INTRODUCTION

OUTLINE OF NEW FEATURES

5. Brake

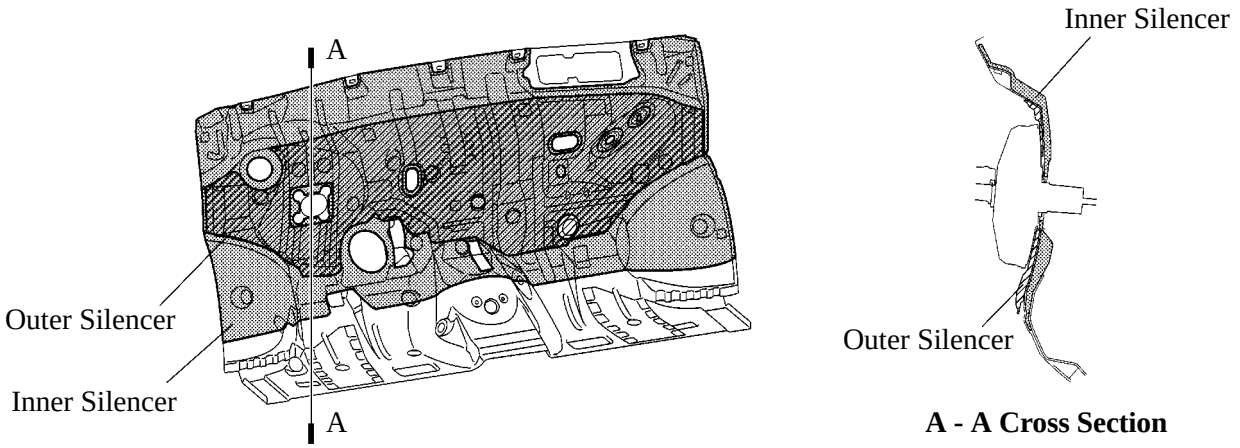
CAN (Controller Area Network) communication is used for the communication circuit between the skid control ECU and the ECM on the models with the brake control system (ABS, EBD, Brake Assist, TRAC, VSC). For details, see page 100.

A - A Cross Section

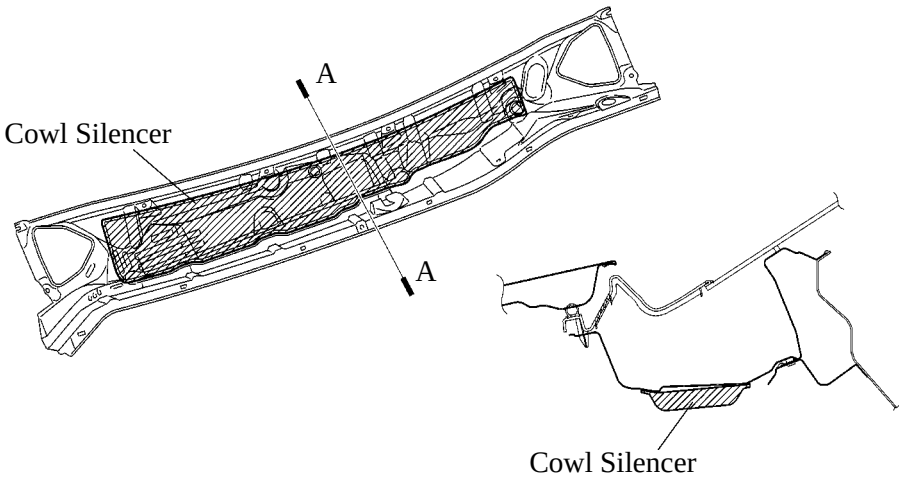
- A high density felt that excels in sound absorption is used in the dash panel outer silencer and dash panel inner silencer to help reduce the amount of engine noise entering the cabin.
